DESCRIPTIVE REPORT

Registry No. F00464

Locality DETROIT AND ST. MARY'S RIVERS

ATLANTIC HYDROGRAPHIC BRANCH
EVALUATION REPORT FOR F00464 (2000)

P15

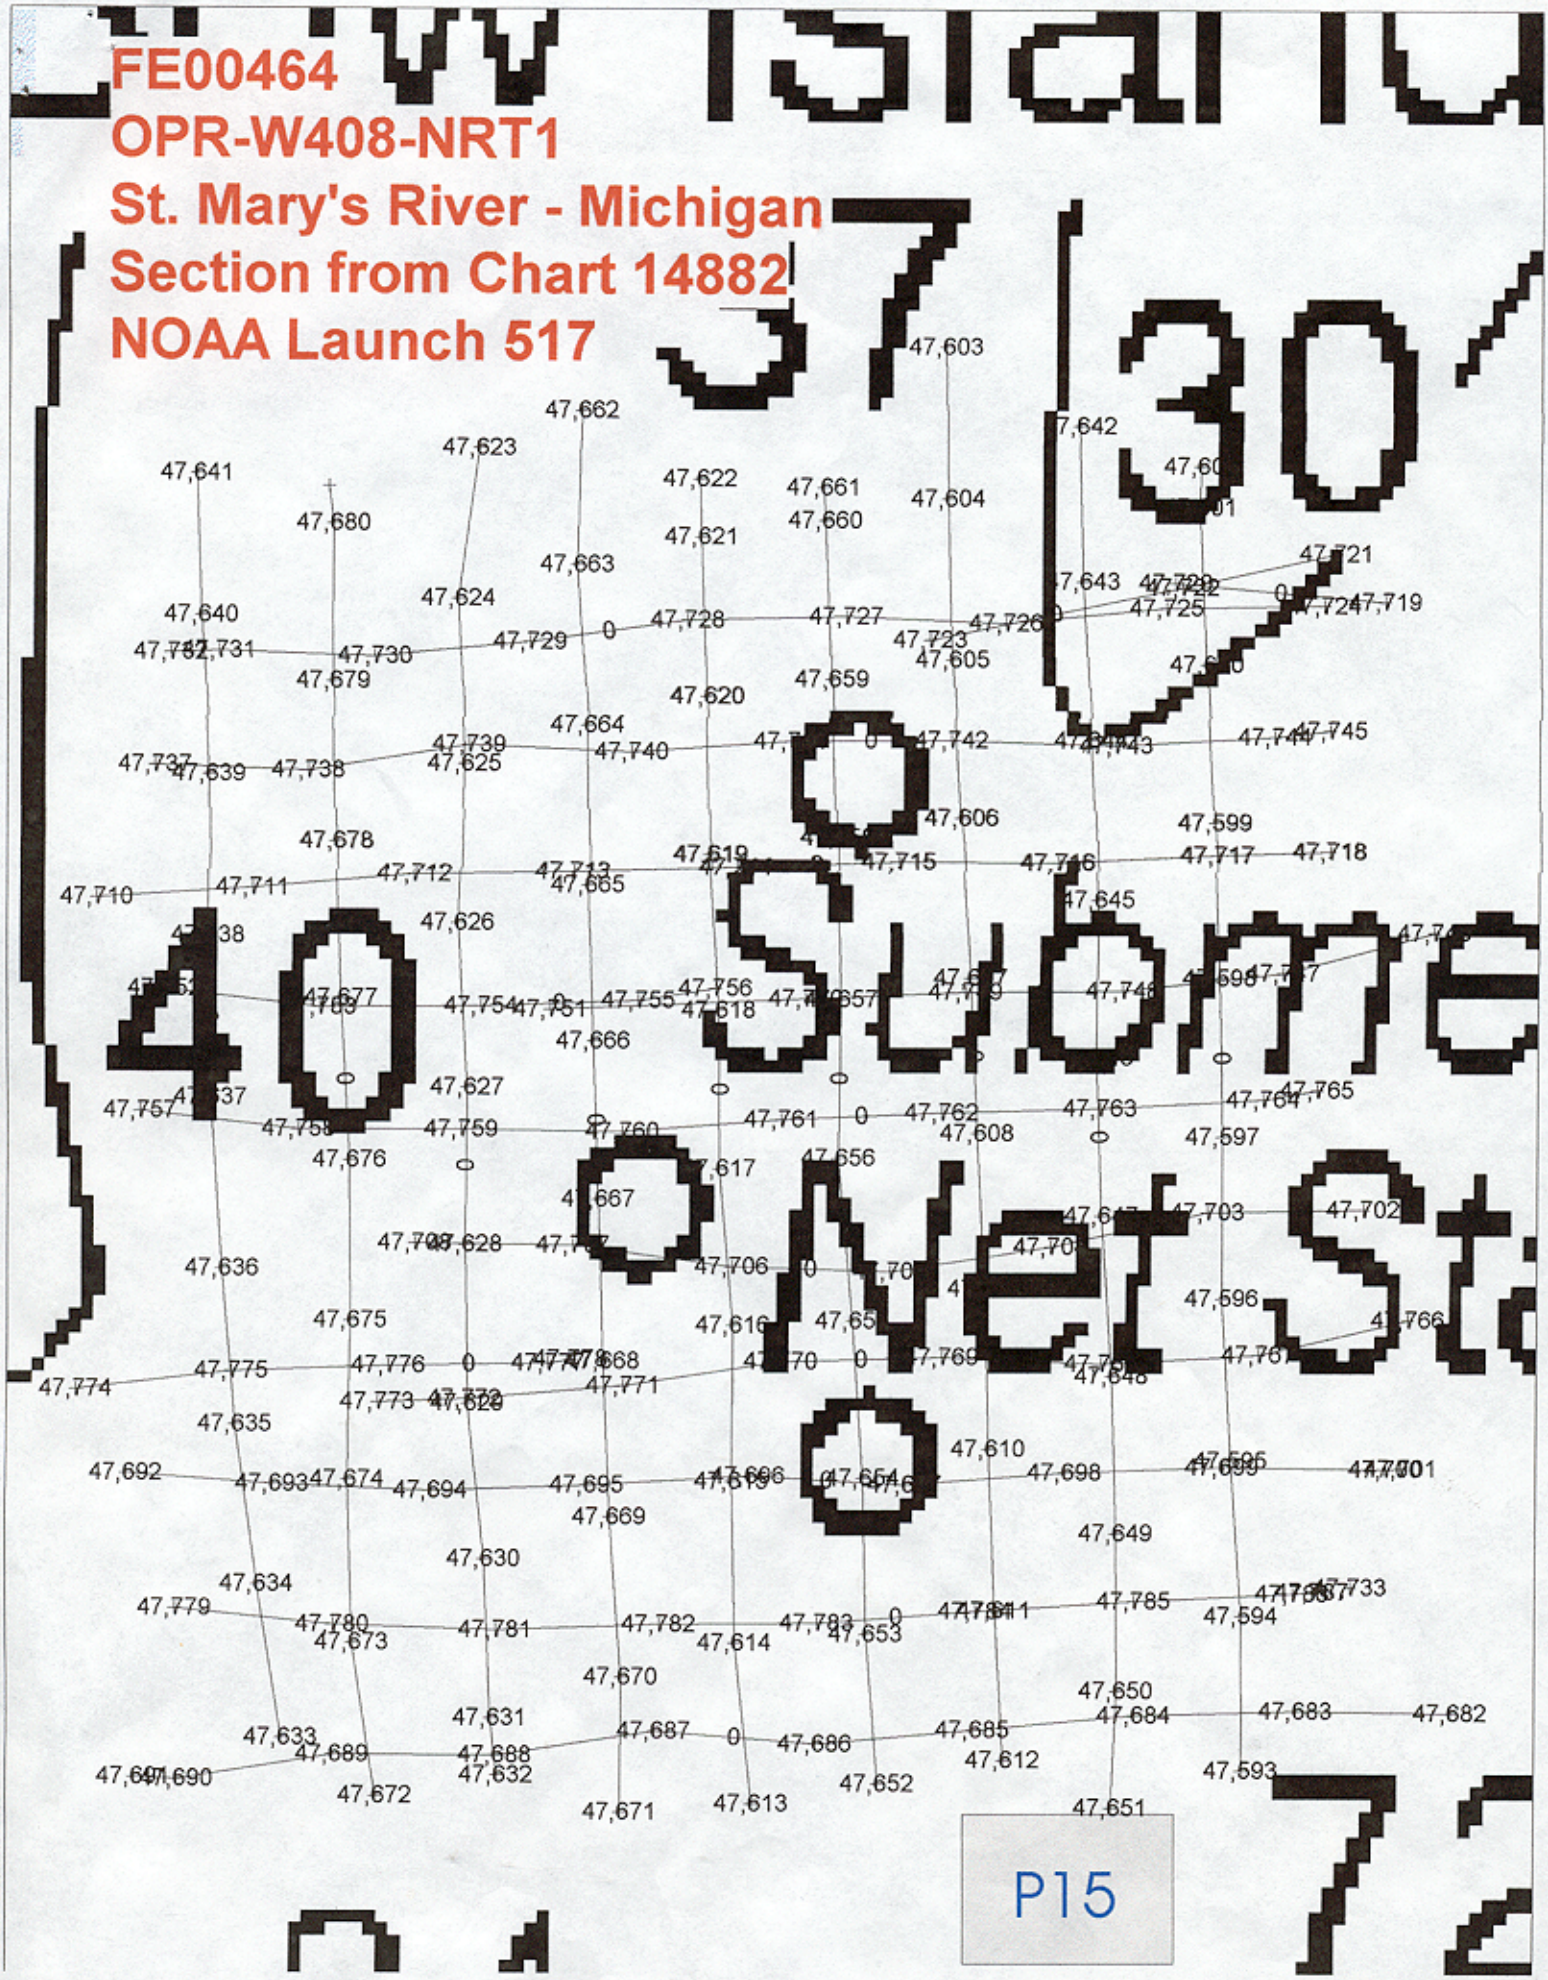
Feature 10 was investigated with 400% coverage side scan sonar. Nothing was found. Sounding, trackline, and swath plots are included with this survey. Concur (1) Plots associated with this item are appended to This Report. See E+A Report Sect D1.H.1. page 4.

1) ENC FEATURE #10 was assigned to verify the

existence of the "submerged net stakes" charted in the vicinity of Latitude 46°02'05.32"N, Longitude 83°49'23.05"W. The field acquired 400% side scan sonar coverage over the charted stakes with negative results. No indication of the submerged net stakes was found by the present survey. It is recommended that the symbols and labels for the "submerged net stakes" be removed from the chart. Also, reposition the (see note D)note in the vicinity of this item. Field plots P9 - P15, appended to the end of this report, show the field work done on this item.

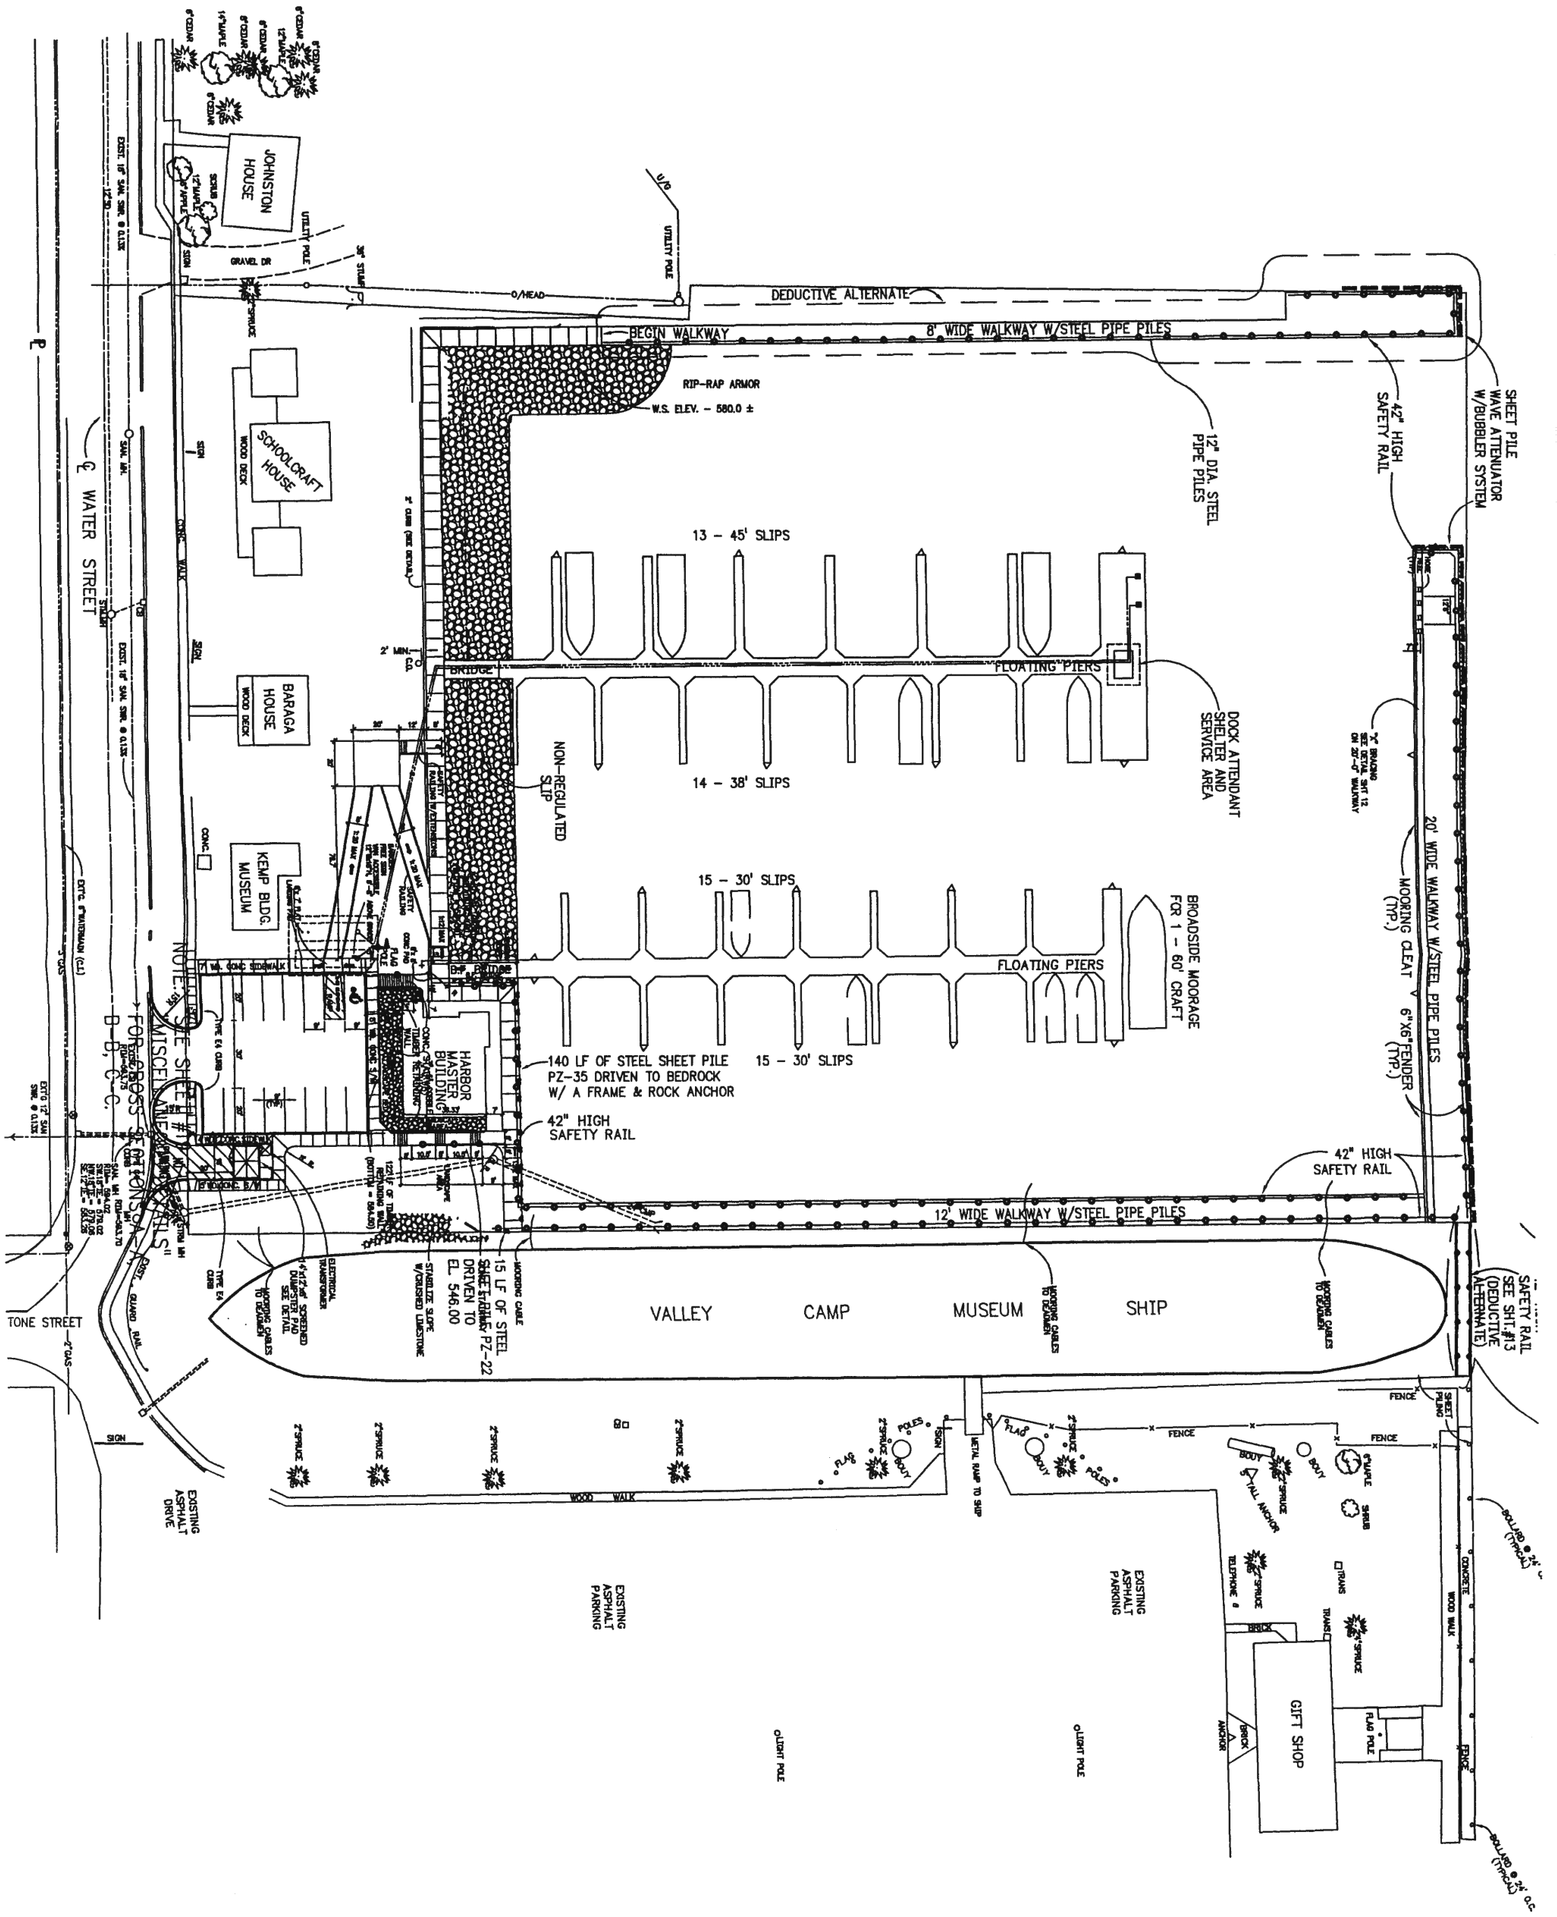
1) ENC FEATURE #19 is an uncharted municipal marina, in the vicinity of Latitude 46°29'58.56"N, Longitude 84°20'13.74"W. This item originates with the present survey. It is recommended that George Kemp Municipal Marina be charted as shown on the present survey. A City of Sault Ste. Marie Site Plan for the Marina is included at the end of this report.
